Service Letter

SL02-412/NIM
December 2002

Fuel Pump Top Cover
L/S35MC, S46-50-60-70MC-C
(Fuel pumps without VIT)
Action Code: AT FIRST OPPORTUNITY

Fuel Pump Top Cover

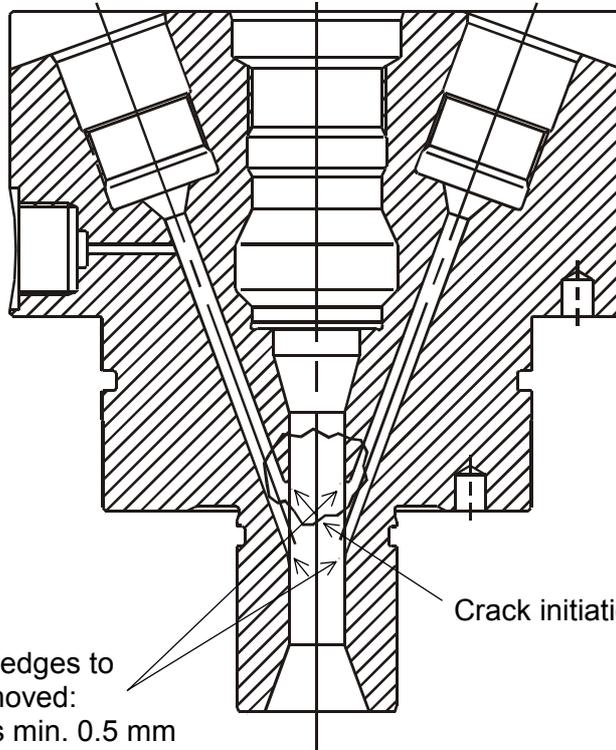
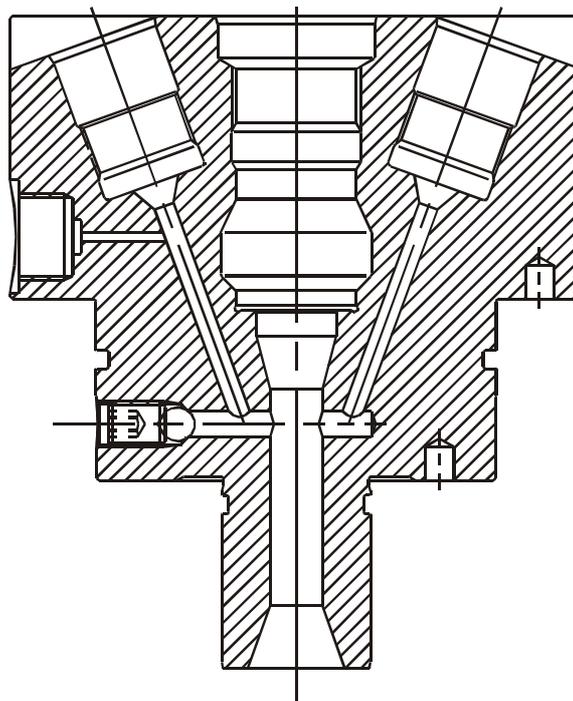
The cracks are initiated at the edge between the central bore and the inclined bores, due to the lack of the specified manual finishing of the transition edge between the central bore and the inclined bore. The crack-initiated area is shown in Fig. 1.

In order to eliminate the need for manual finishing during production, and as an alternative to this, we have introduced a modified design for future top covers. The design is shown in Fig. 2.

The modification involves the introduction of a horizontal bore connecting the vertical central bore and the inclined bores.

Sharp edges to
be removed:
Radius min. 0.5 mm

Crack initiation area

We recommend checking whether the spare cover is of the original design. If this is the case, please check the transition between the vertical bore and the inclined bores. The transition area must have a radius of min. 0.5 mm. On the spare top cover, the sharp edge must be removed and a rounding of min 0.5 mm must be made.
